AGRICULTURE, SUNDERLAND, 150000

NOTICE OF INTENT
I.D. LETTER C

TO: ALL INTERESTED PARTIES
FROM: AMHERST BOARD OF HEALTH
RE: VARIANCE REQUEST TO LOCAL AMENDMENTS OF
Title V by Jeff Wood for property
on Rte. 116

RE: Plan Review - Route 116 Lot

PROPOSED LAYOUT FOR
SINGLE FAMILY RESIDENCE AT
RTE 116 AMHERST
FOR: JEFFREY WOOD
BY: RICHARD SCOTT, P.E.
SCALE: 1" = 40' DATE 3-21-87

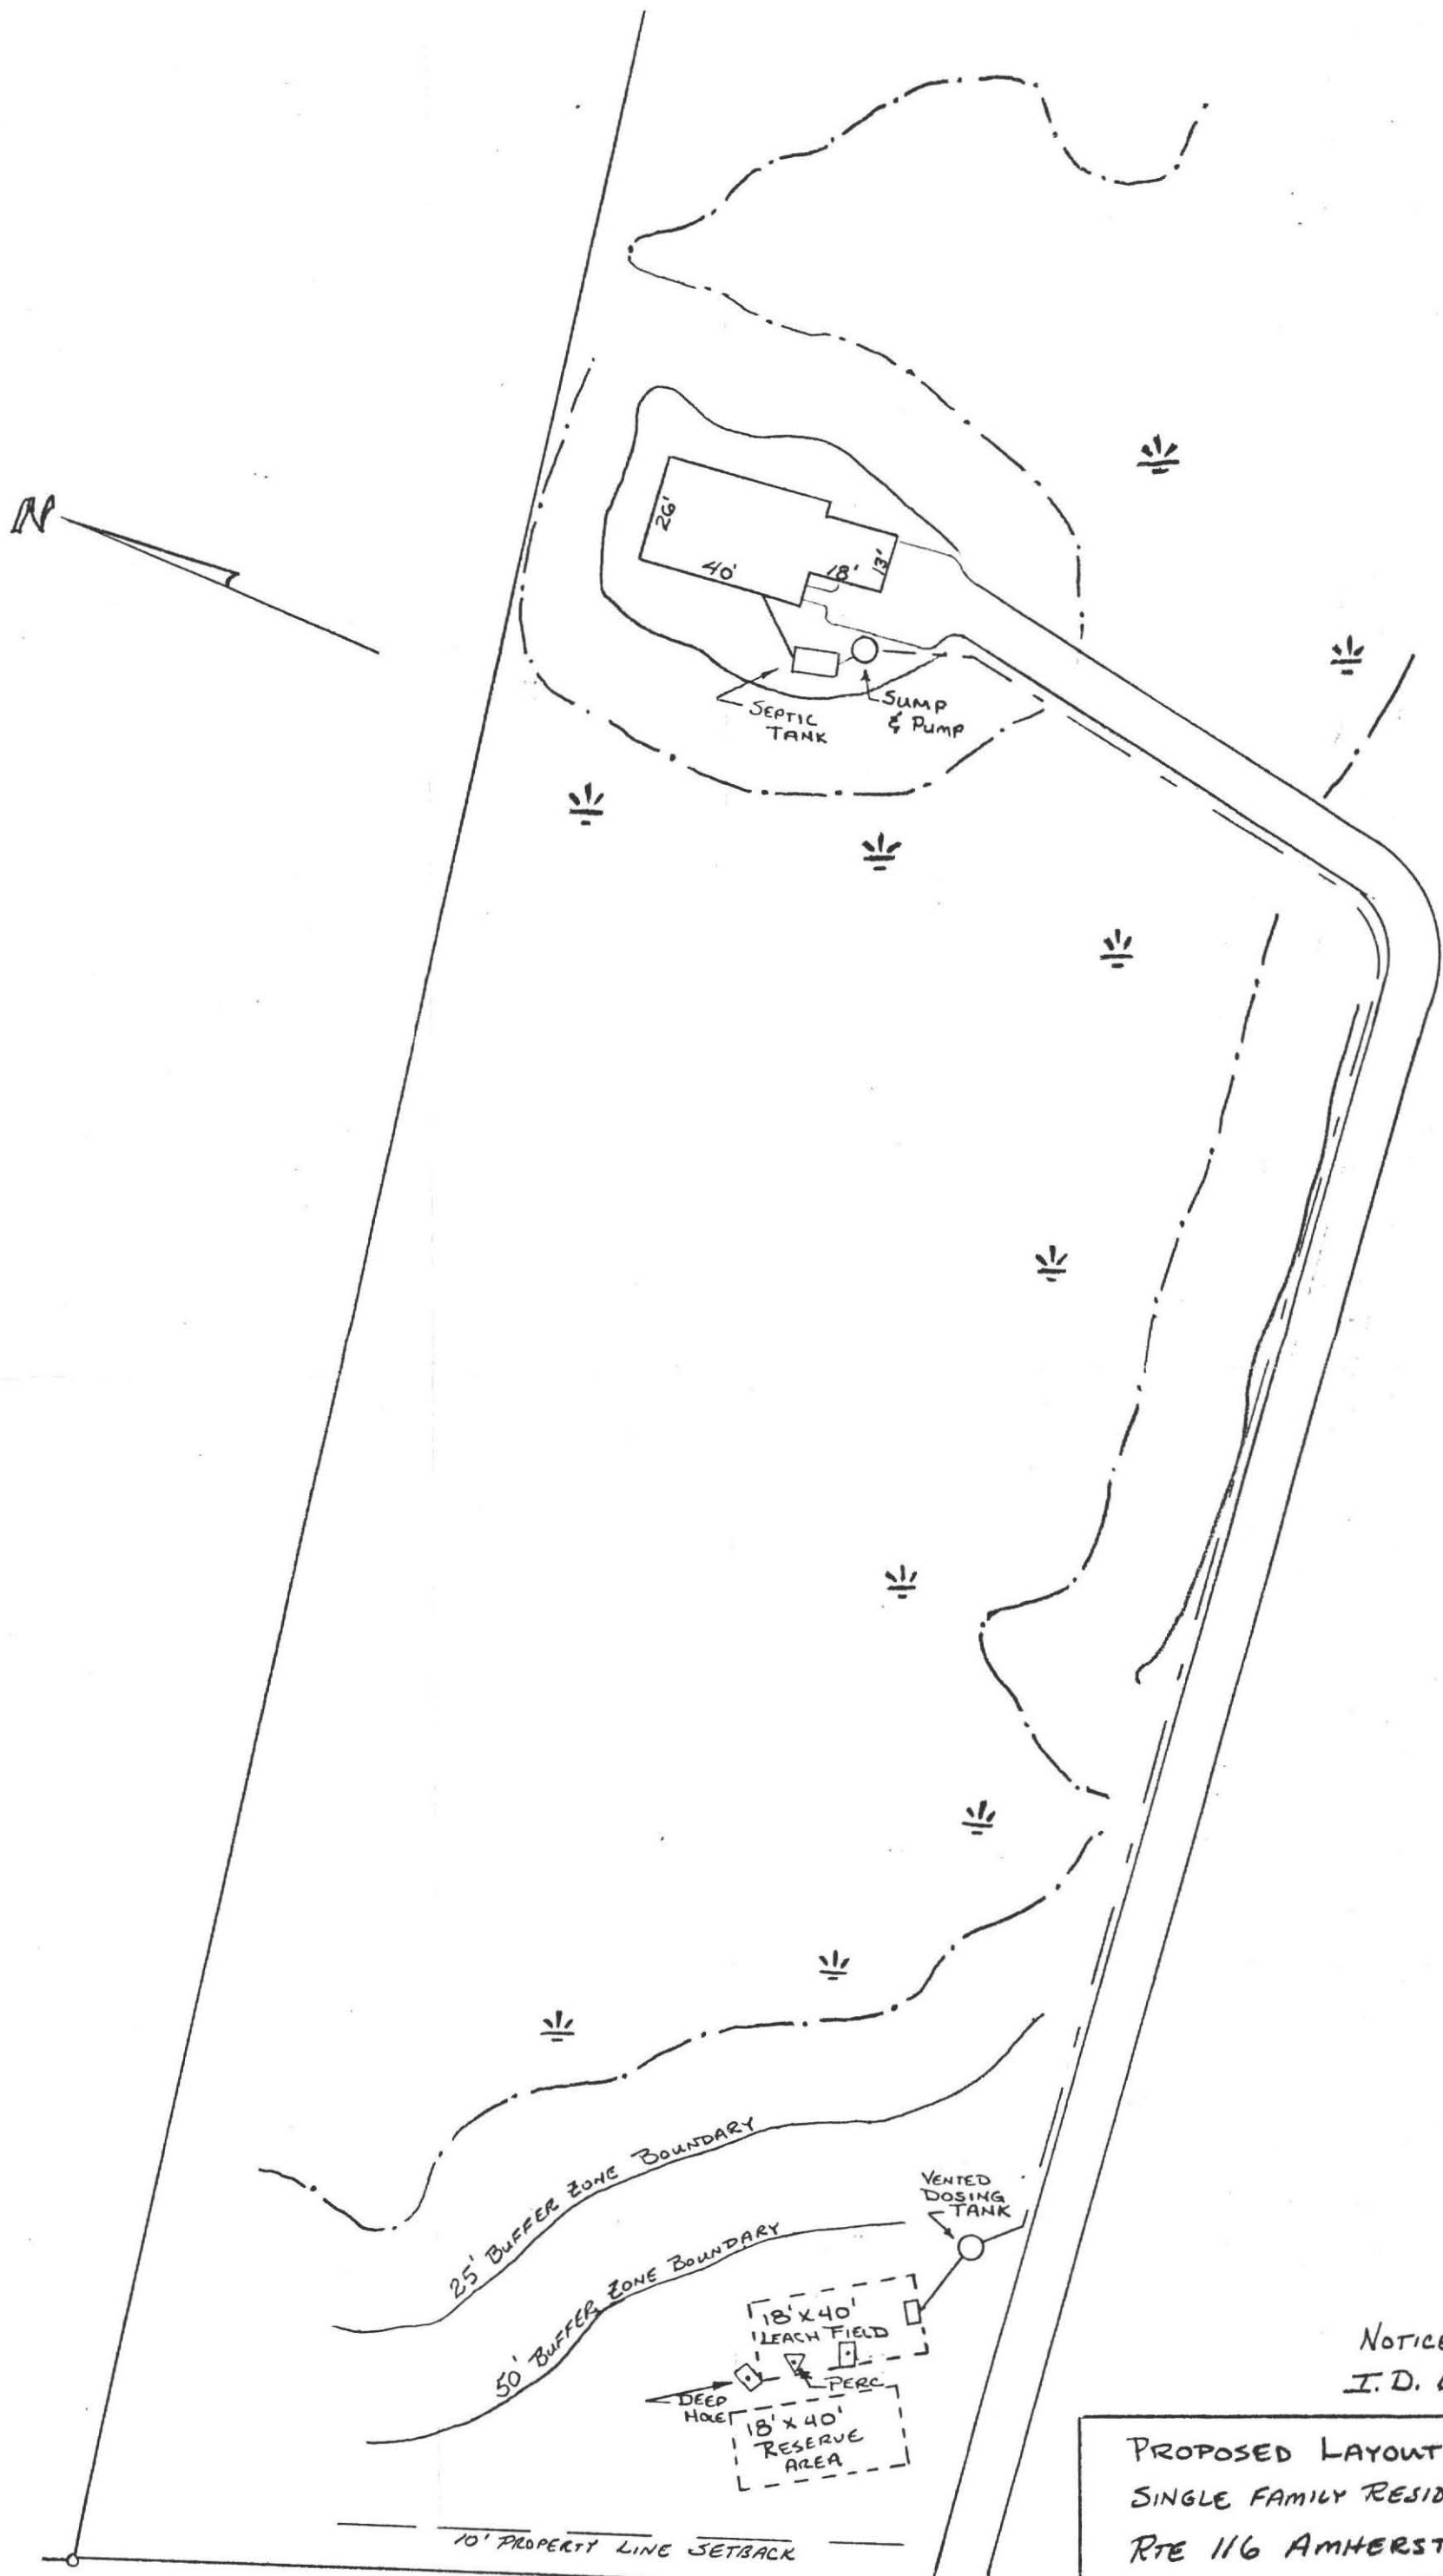
The Perc and Deep Hole location were not transferred onto the third and newest system layout which is dated March 21, 1987. Also enclosed here are four copies of the March 21, 1987 plan with the revision to add back that information. Thanks for your attention to this detail.

REVISED: 11-1-88 ADDED 50' SETBACK ZONES, MOVED RESERVE,
ADDED PERC LOCATION

REVISED: 11-1-88 ADDED 50' SETBACK ZONES, MOVED RESERVE,
OPEN PERCOLATION

REVISED: 11-1-88 ADDED 50' SETBACK ZONES, MOVED RESERVE, ADDED PERC LOCATION
